Subject:
Addendum to the Building 2
In-Situ Reactive Zone Pilot Test Workplan
Former C-6 Facility, Los Angeles, California

Date:
July 31, 2002

BOEING REALTY CORPORATION
FORMER C-6 FACILITY
LOS ANGELES, CALIFORNIA

BUILDING 2 - PROPOSED IRZ AMENDMENT POINTS AND MONITORING WEL LAYOUT

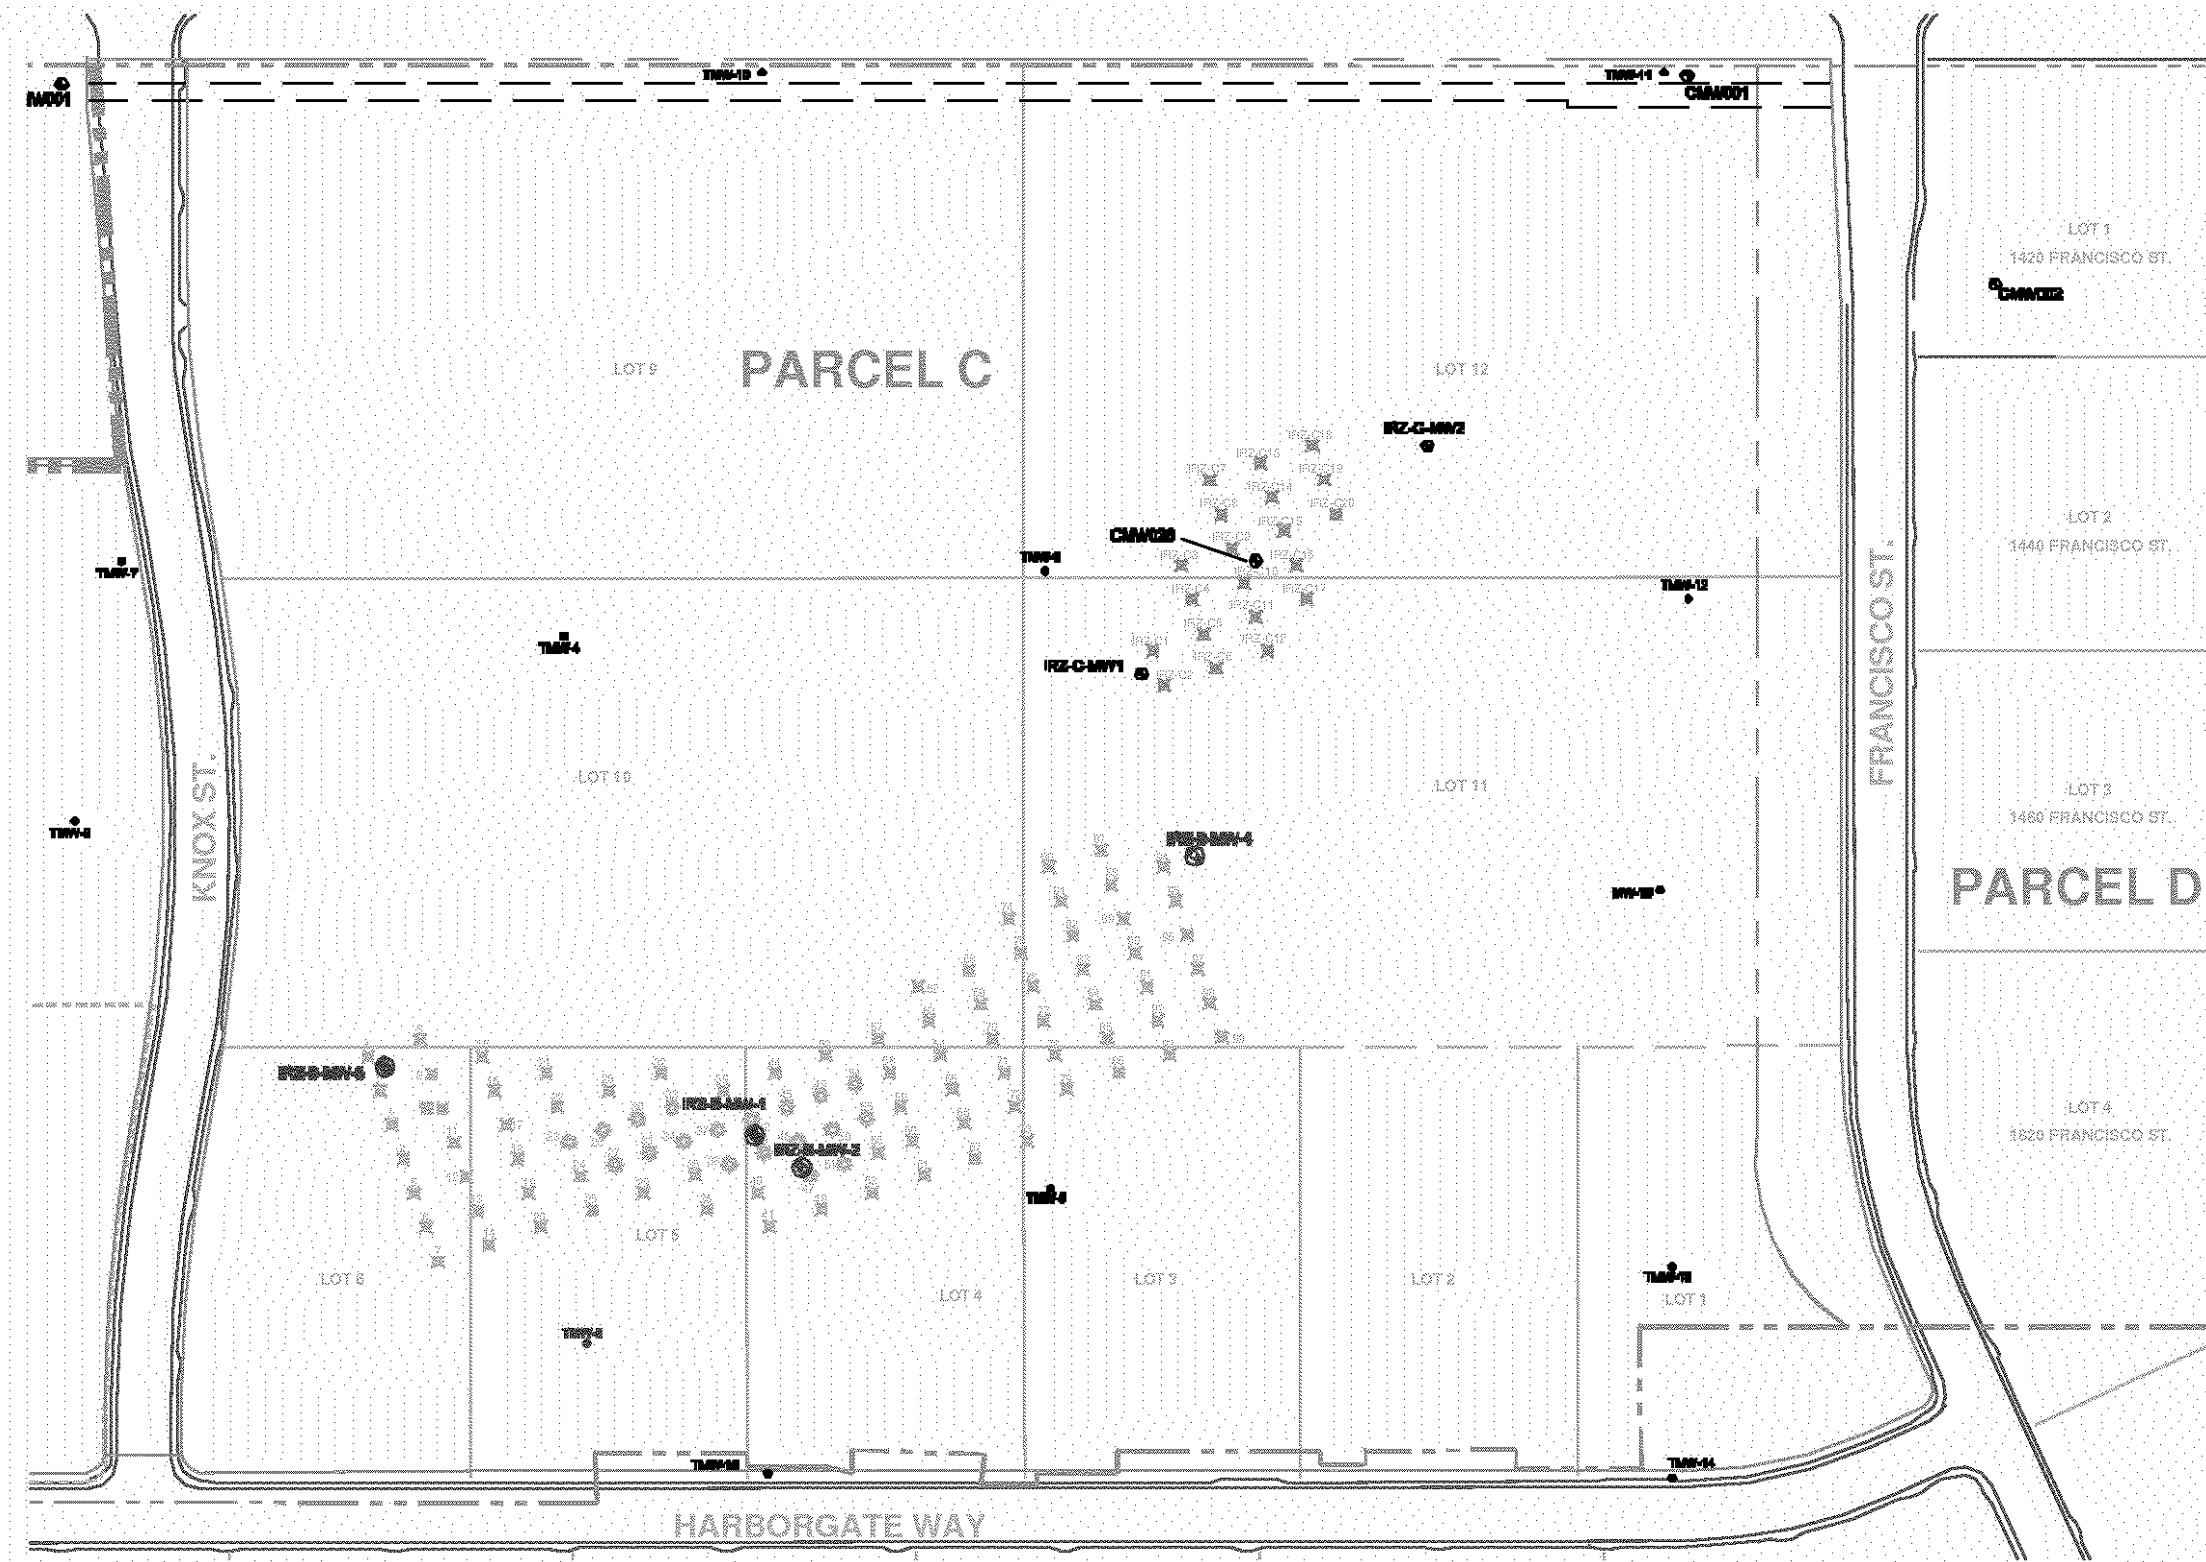
The C-sand pilot program will be integrated into the overall Building 2 pilot test program described in the approved August 2001 Workplan. Approximately 20 IRZ amendment points and 5 monitoring wells will be installed in the targeted source-area within the C-Sand. All baseline sampling, amendment addition, and groundwater monitoring will be conducted in accordance with the approved Workplan. Sections 2.1 and 2.2 describe the amendment point and monitoring well layout and construction details.

Temporary IRZ amendment points will be installed within the C-Sand source-area zone to deliver carbohydrate solution. The source-area zone is defined as the area where concentrations of TCE are above 5,000 µg/L. Based on the groundwater data, the specific targeted aerial extent is within the C-Sand from approximately 100-125 ft bgs with an area of approximately 9,000 square feet.

Preliminary design calculations using estimations of soil permeability (10^{-4} to 10^{-5} centimeter per second), groundwater flow velocity (average velocity of 15 feet per year), and anticipated amendment half-life resulted in a per point radius of influence (ROI) of 15 feet. Therefore, 20 amendment points will be spaced approximately 30 feet apart to establish a treatment line that is perpendicular to the direction of groundwater flow. In addition, the treatment lines will be spaced on 45-foot centers; this spacing is based on a minimum one-year travel time between lines. Figure 2 illustrates the proposed locations of the IRZ amendment points.

Five new monitoring wells will be installed to monitor the progress of the pilot study program in the C-Sand. These wells will consist of single wells and are identified as IRZ-C-MW1, CMW-001, IRZ-C-MWZ, CMW-002, and CMW-026 (Figure 2). The locations and rationale for each of these wells are summarized below.

- IRZ-C-MW1: The purpose of this well is to monitor groundwater from a background location (upgradient of the treatment area). This will be a single well casing to monitor the C-Sand and will be located approximately 30 feet upgradient of the first treatment row.
- CMW-026: The purpose of this well is to monitor groundwater in the C-Sand. The well will be located at the estimated edge of the zone of influence, approximately 15 downgradient of amendment point IRZ-C10.
- IRZ-C-MW2, CMW-001, and CMW-002: The purpose of these wells is to monitor groundwater in the C-Sand and to assess if the reactive zone has traveled outside the treatment area. IRZ-C-MW2 will be located approximately 90 feet downgradient of the furthest downgradient treatment row. Wells CMW-001 and CMW-002 will be located approximately 450 and 560 feet downgradient from the furthest downgradient treatment row, respectively.

TYPICAL CONSTRUCTION DETAILS FOR IRZ AMENDMENT POINTS AND MONITORING WELLS

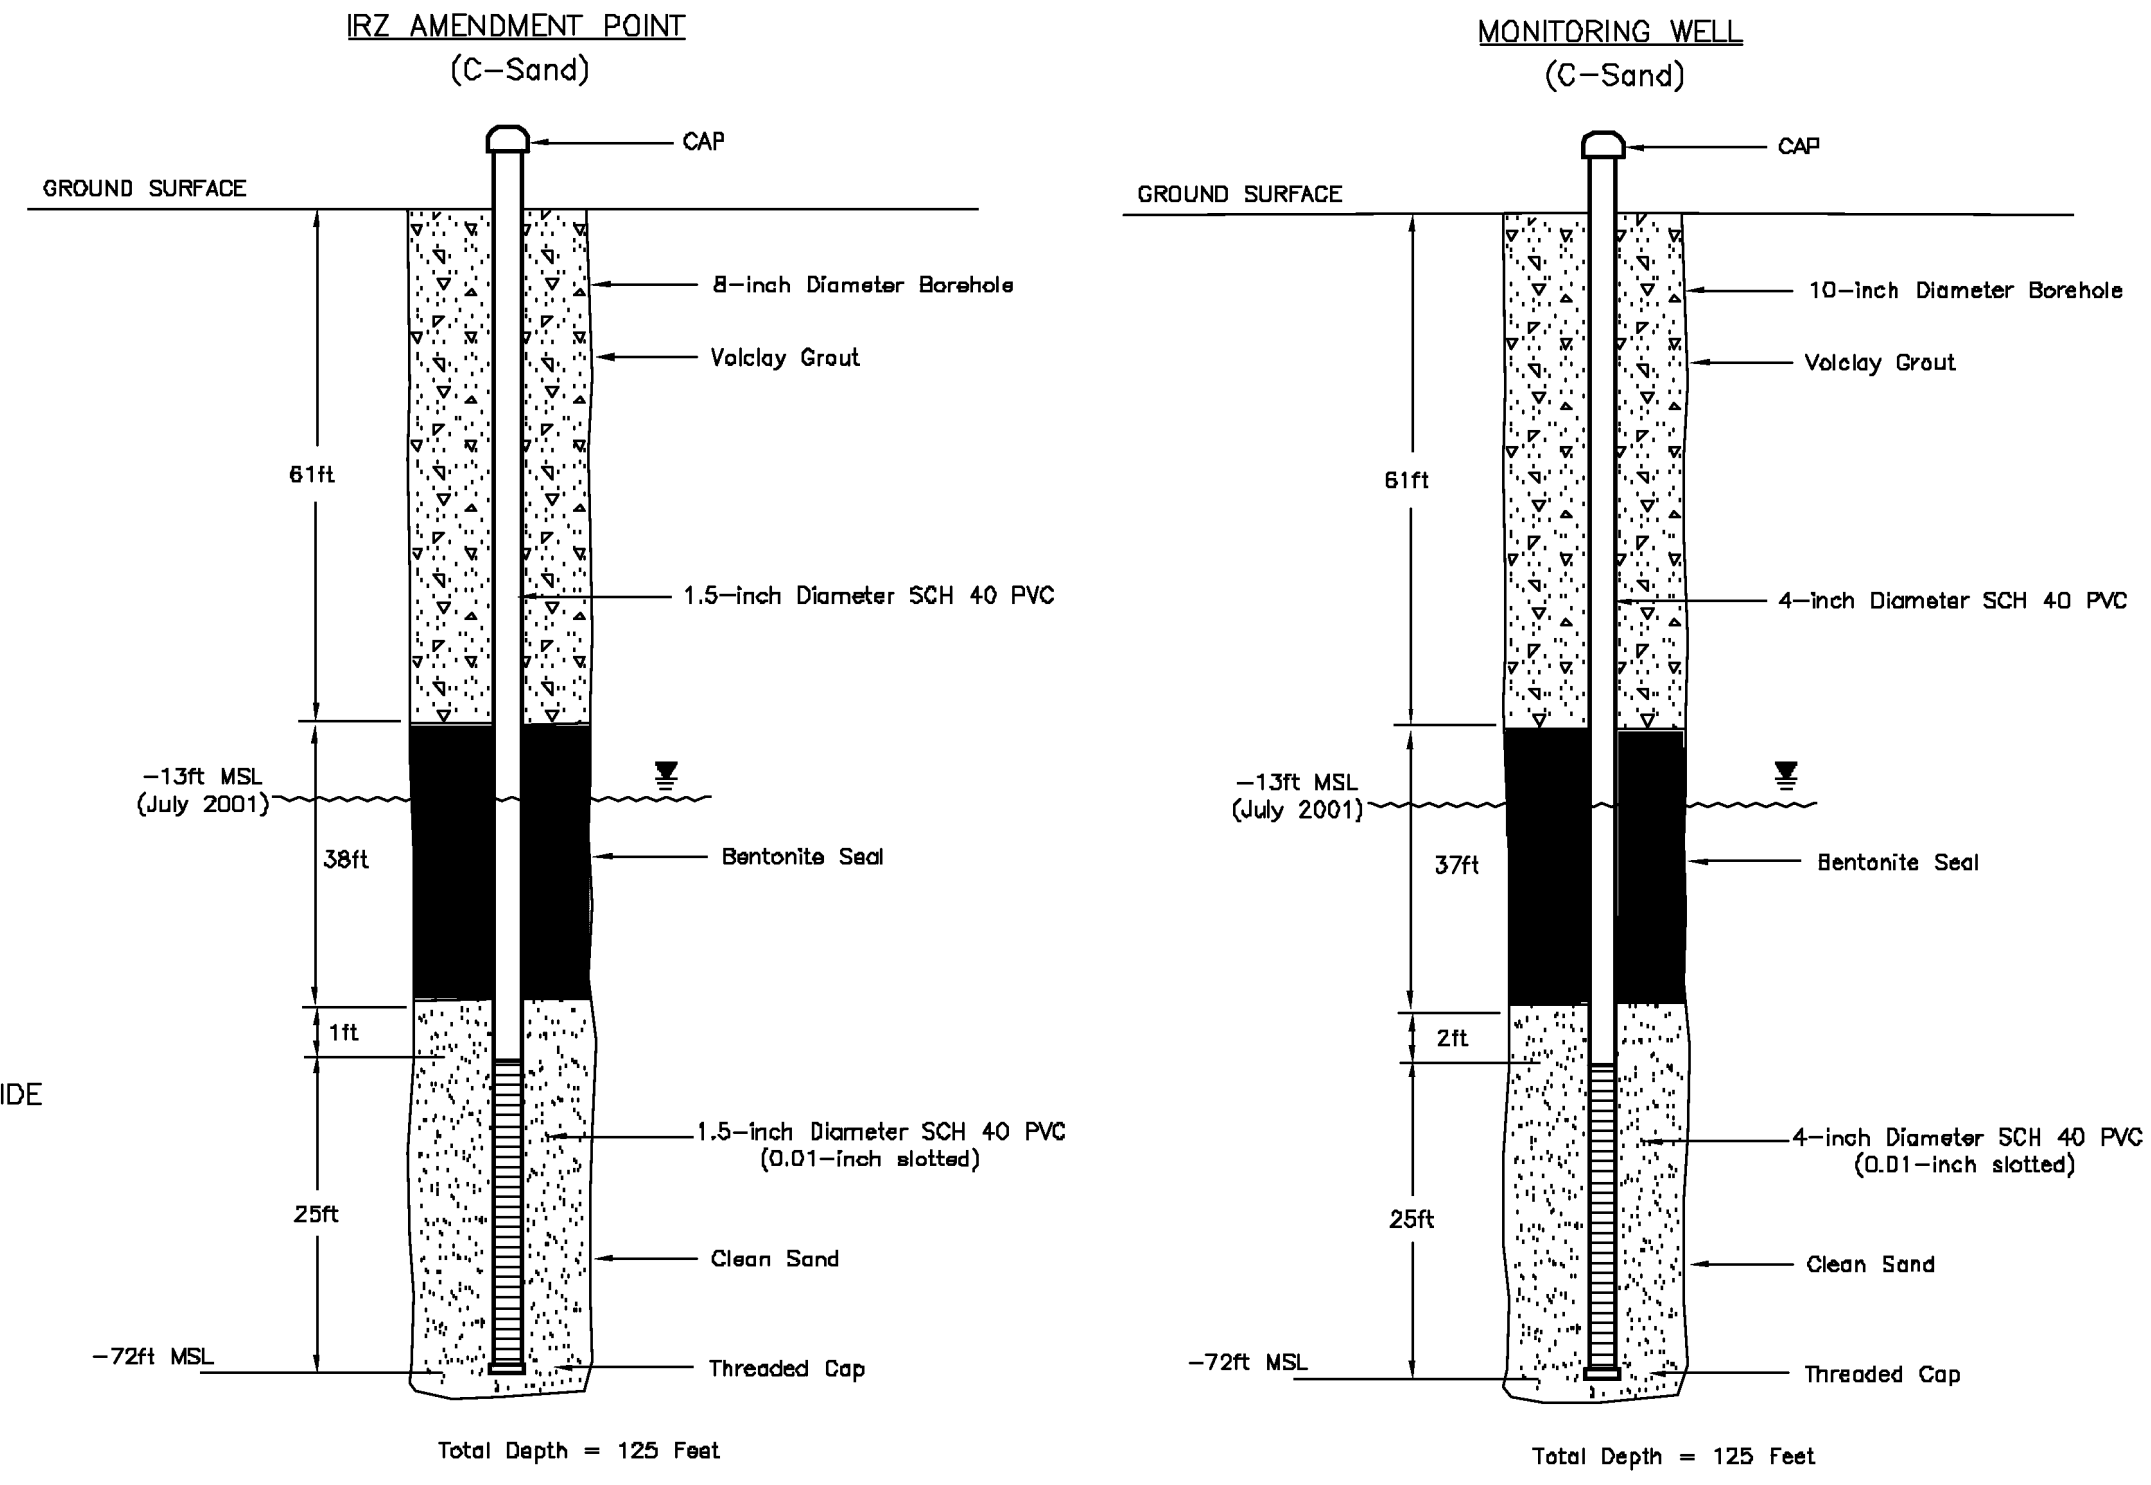
The IRZ amendment points will be installed using a hollow-stem-auger drill rig. A 1.5-inch diameter schedule 40 polyvinyl chloride (PVC) casing with 0.01-inch slotted screen from approximately 100 to 125 feet bgs will be inserted into the 8-inch diameter borehole. Clean sand will be placed in the borehole to approximately 1 foot above the well screen and 38 feet of bentonite chips will then be placed above the sand and hydrated in place to create a seal around the PVC casing. The top of this bentonite will be approximately 5 feet above groundwater. Volclay grout will then be placed in the annular space to ground surface.

A construction permit will be obtained from the Los Angeles County Department of Health Services for the amendment points prior to installation. The typical amendment point construction detail is shown in Figure 3.

The groundwater monitoring wells will be installed using a hollow-stem-auger drill rig. A 4-inch diameter schedule 40 PVC casing with 0.01-inch slotted screen from 100 to 125 feet will be inserted into the 10-inch diameter borehole. Clean sand will be placed in the borehole to approximately 2 foot above the well screen and 38 feet of bentonite chips will then be placed above the sand and hydrated in place to create a seal. Volclay grout will then be placed in the annular space to ground surface.

Well construction permits will be obtained from the Los Angeles County Department of Health Service prior to installation. Typical monitoring well construction is presented in Figure 3.
